**SANDY BEACH NORTH DEVELOPMENT
RESPONSE TO ENVIRONMENTAL CONSTRAINTS ANALYSIS LOT 22 DP 1070182, PACIFIC
HIGHWAY, SANDY BEACH NORTH (SAINTY AND ASSOCIATES, 2006)**

SANDY SHORES DEVELOPMENTS PTY LTD

**SCIENTIFIC ASSESSMENT OF
ENTRANCE BERM ELEVATION FOR
HEARNS LAKE, SANDY BEACH NORTH**

**Issue No. 2
JANUARY 2007**

COPY OF DRAWINGS PREPARED BY ASQUITH & DE WITT SHOWING THE
ENTRANCE BERM PROFILE IN JUNE 2004

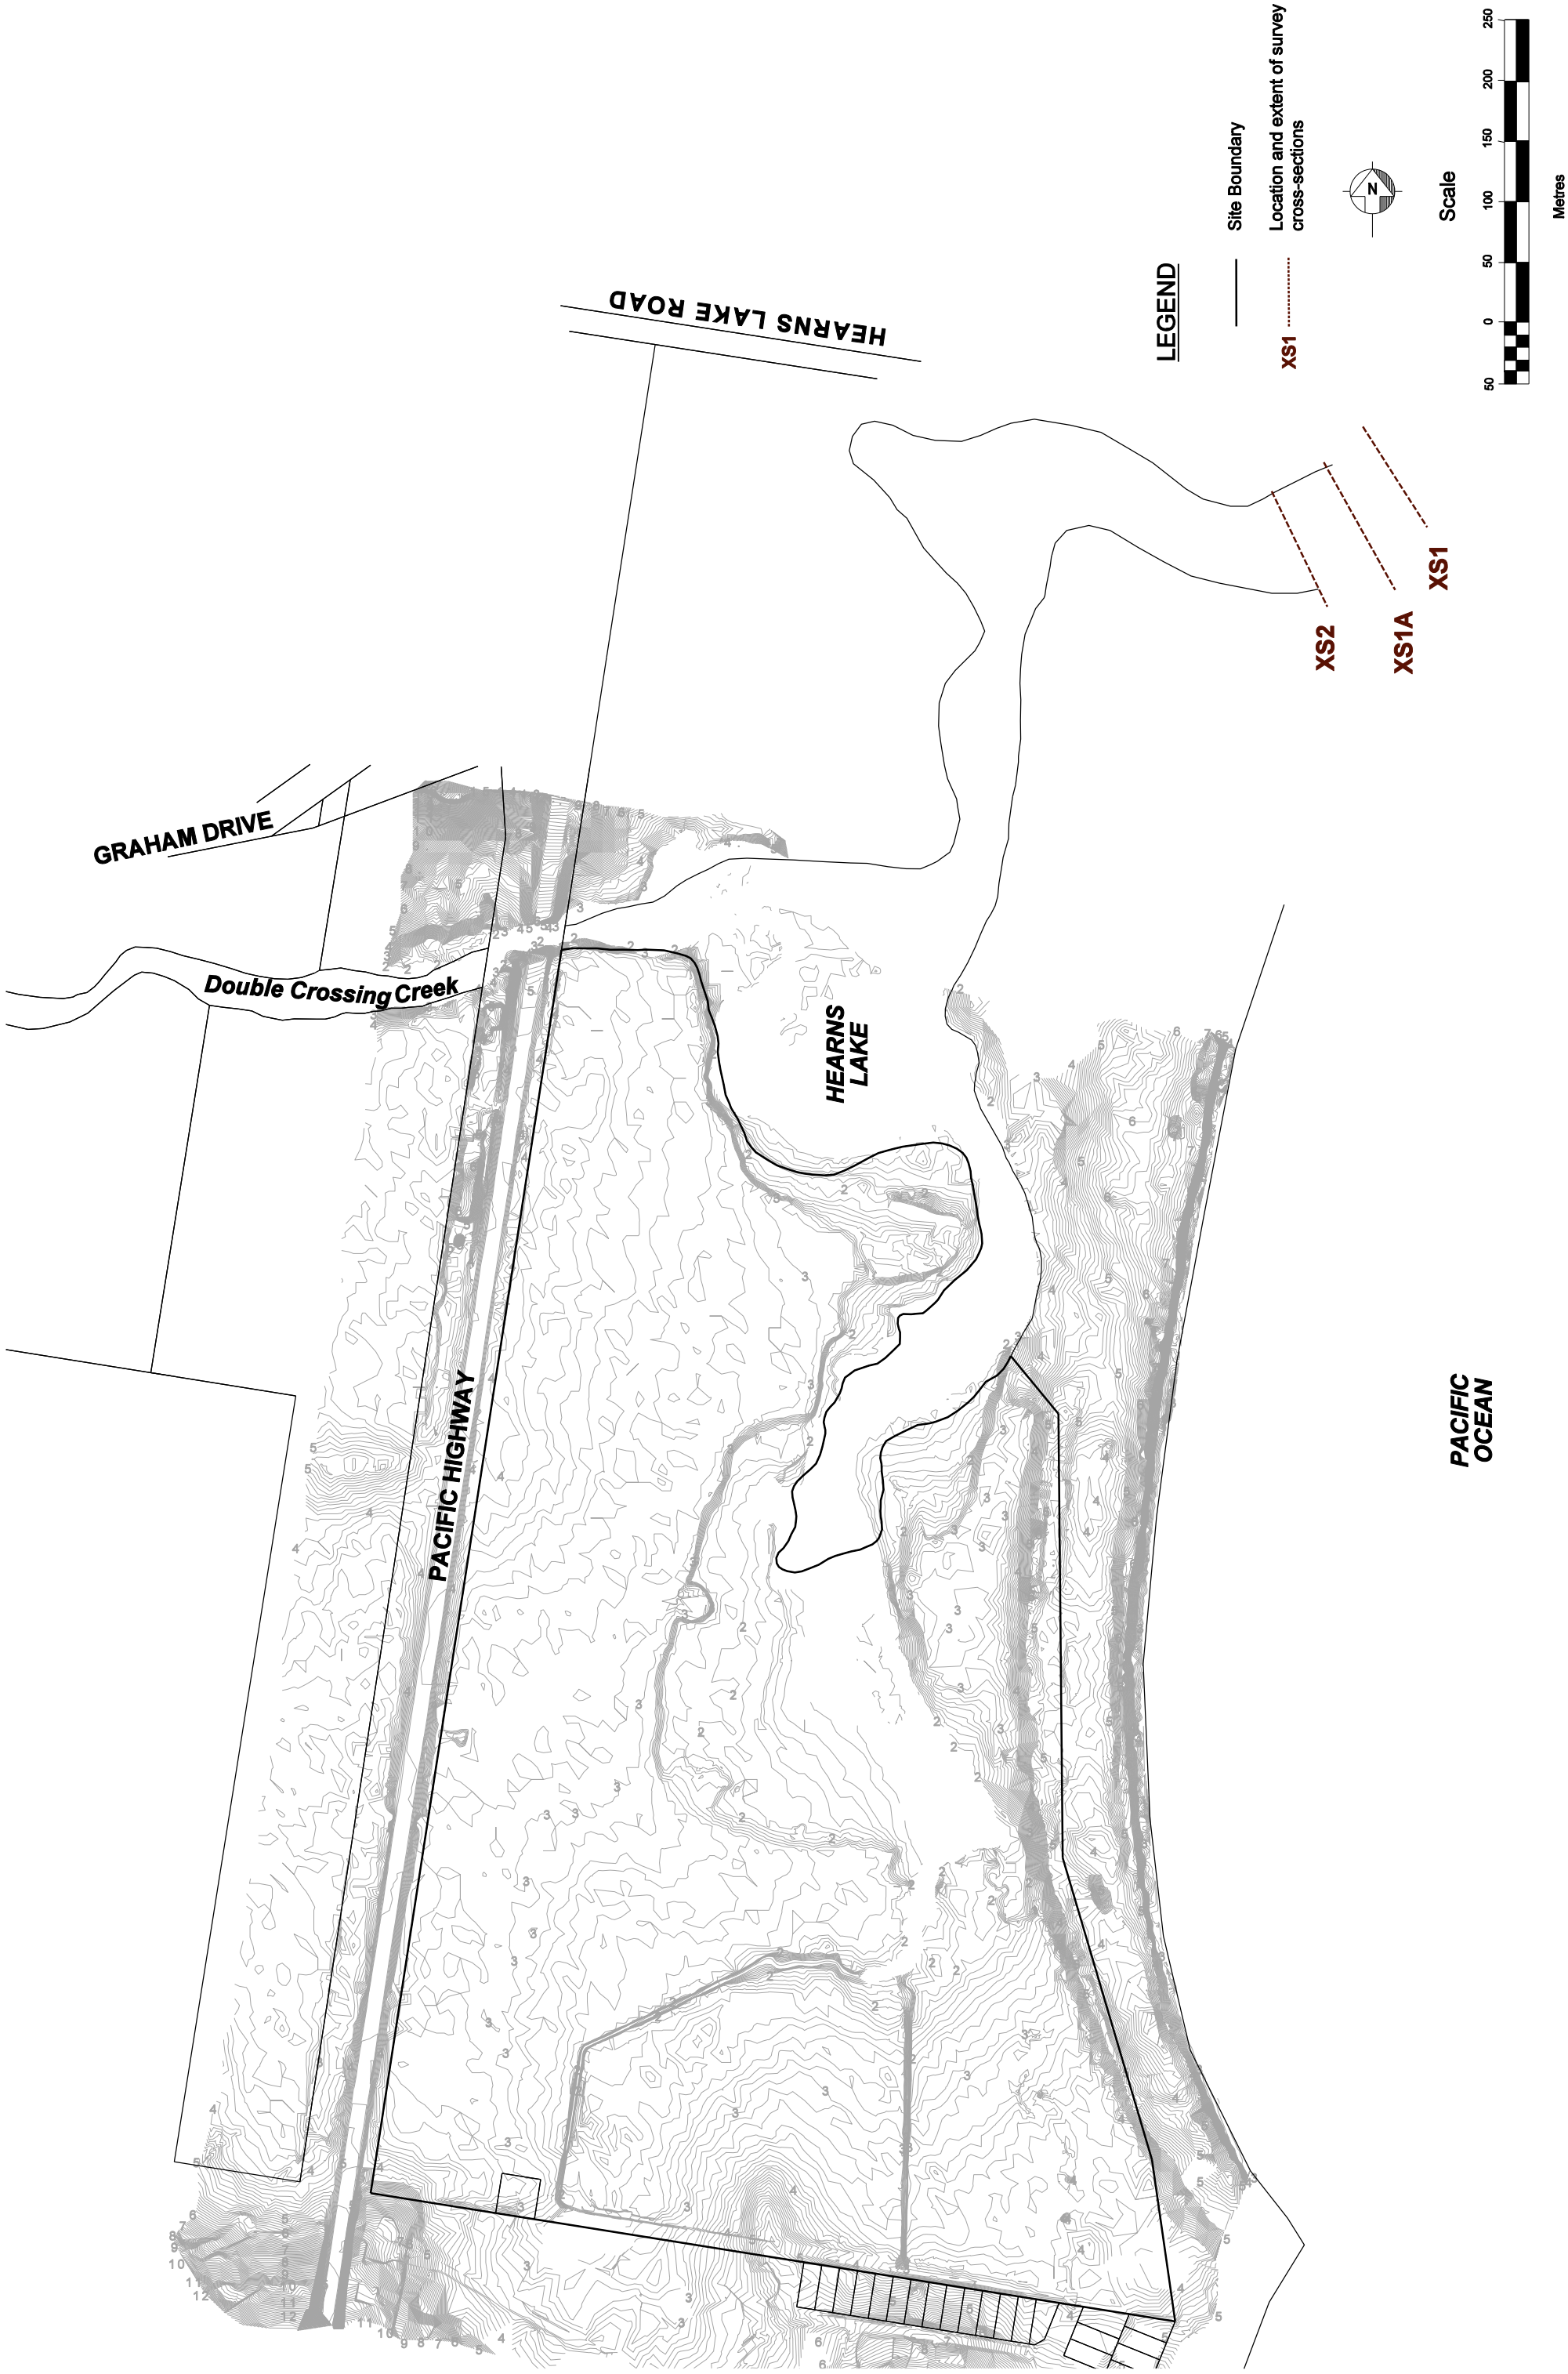
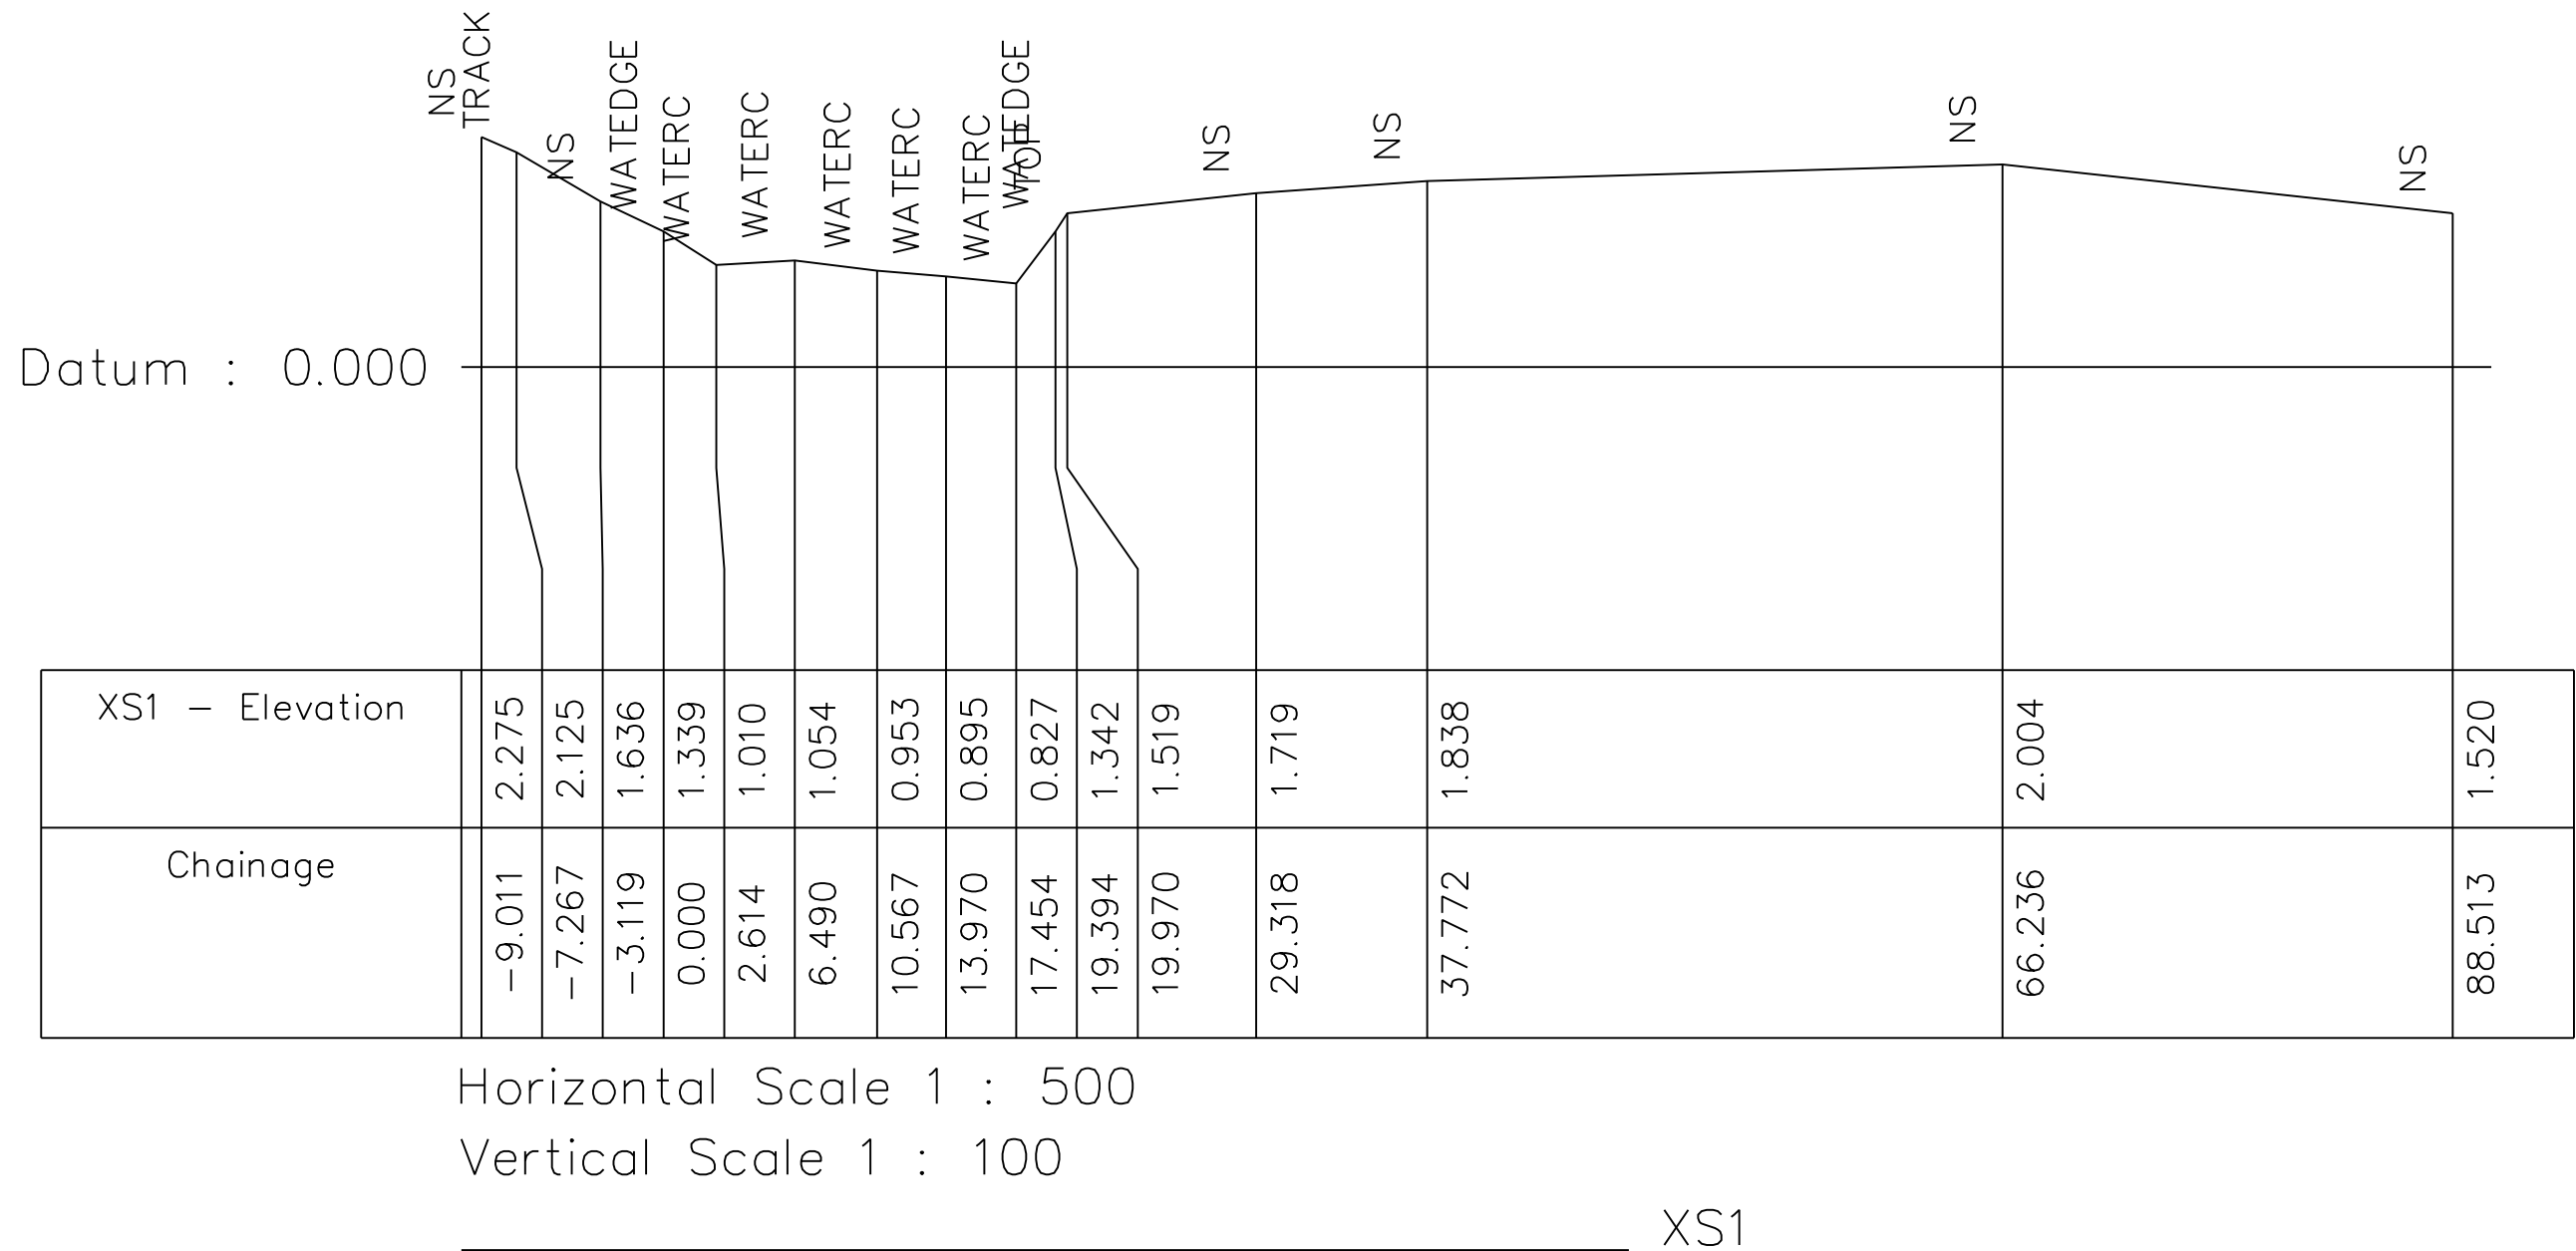
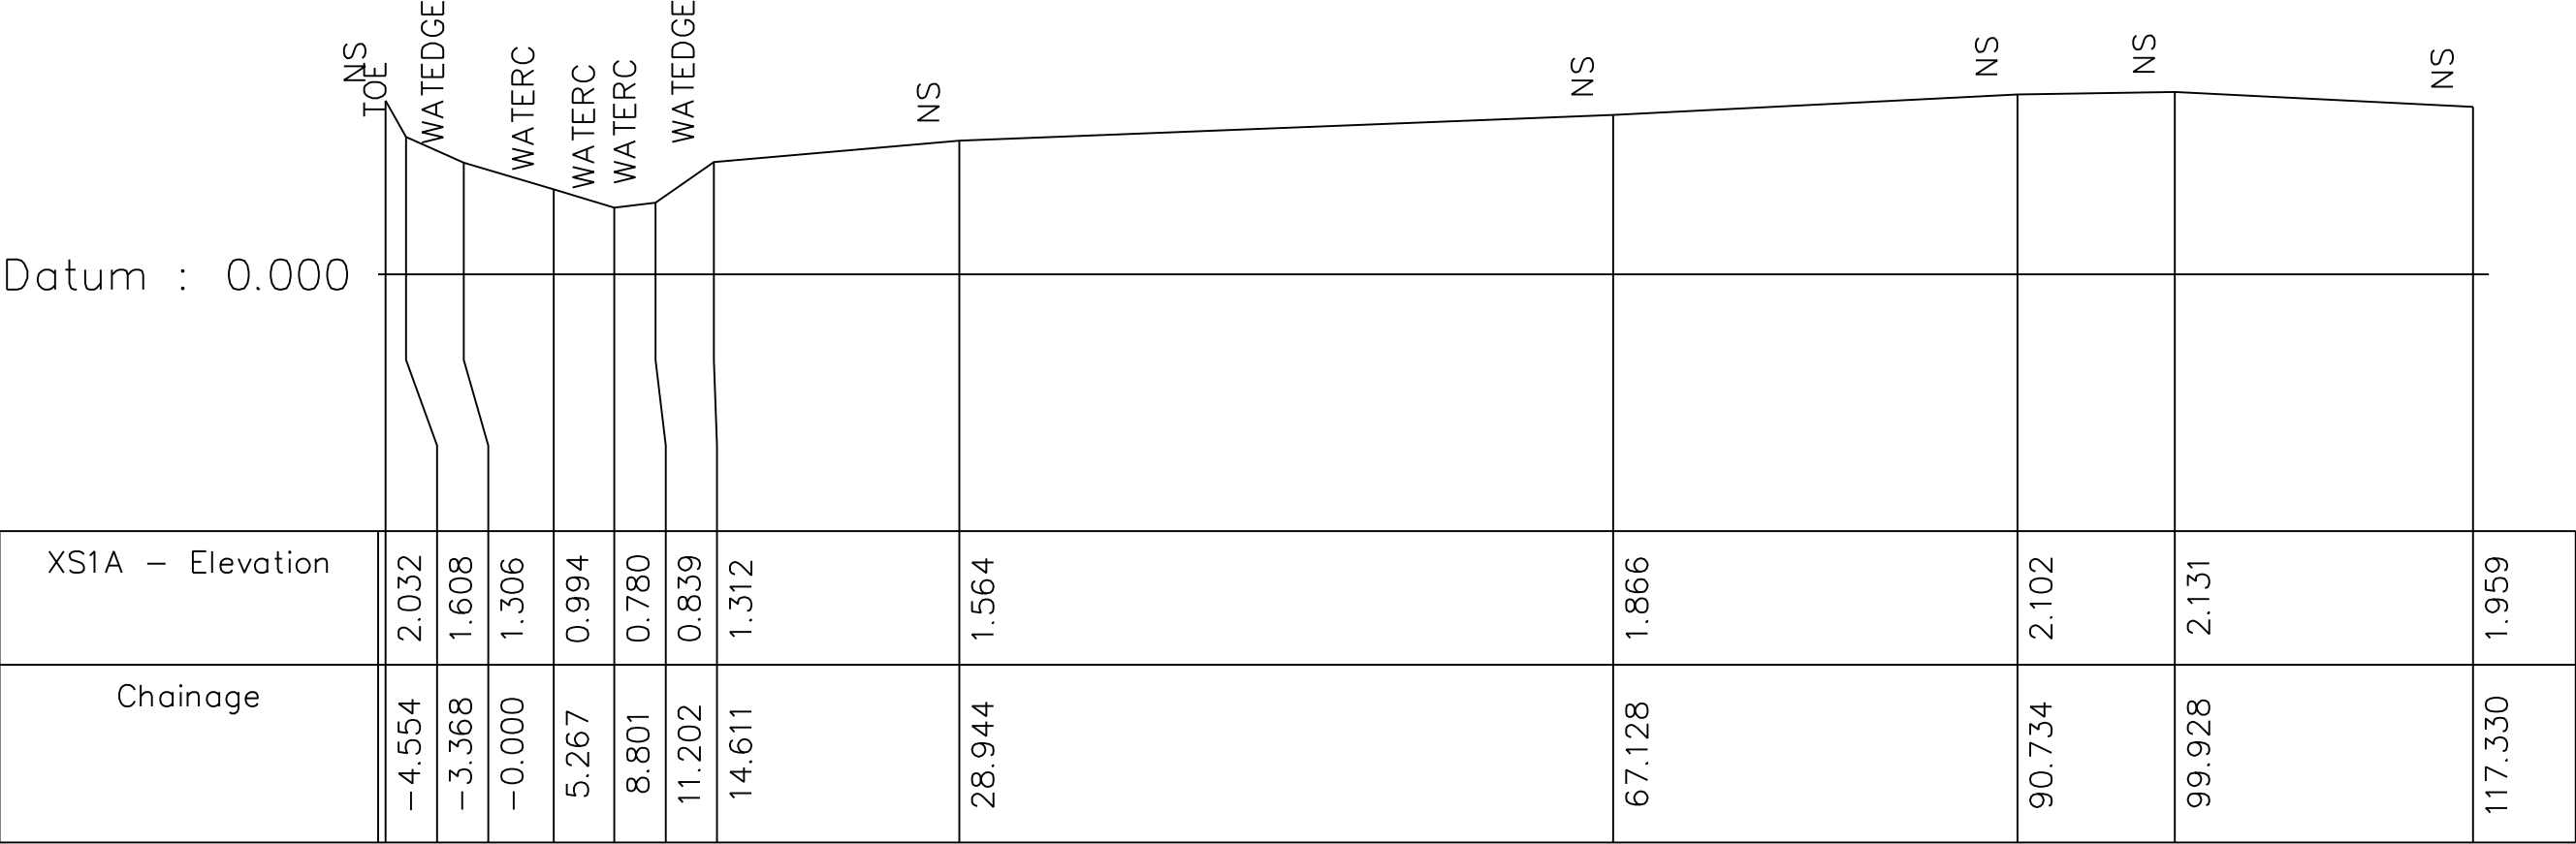
As shown by the drawings, the invert of the pilot channel in the beach berm had an elevation of 1.6 mAHD (*refer cross-sections XS 1, XS 1A and XS 2 in Appendix B*). The average level of the beach berm was approximately 2.0 mAHD. These values are compatible with an entrance which has an annual opening regime; that is, breakout will be initiated by a lake rise in the order of only 1 to 1.5 metres.

Therefore, it is our professional opinion that the invert of the pilot channel in the beach berm varies between limits of 1.6 and 2.0 mAHD. There is no evidence to support the 3.0 mAHD elevation assumed by Sainty & Associates.
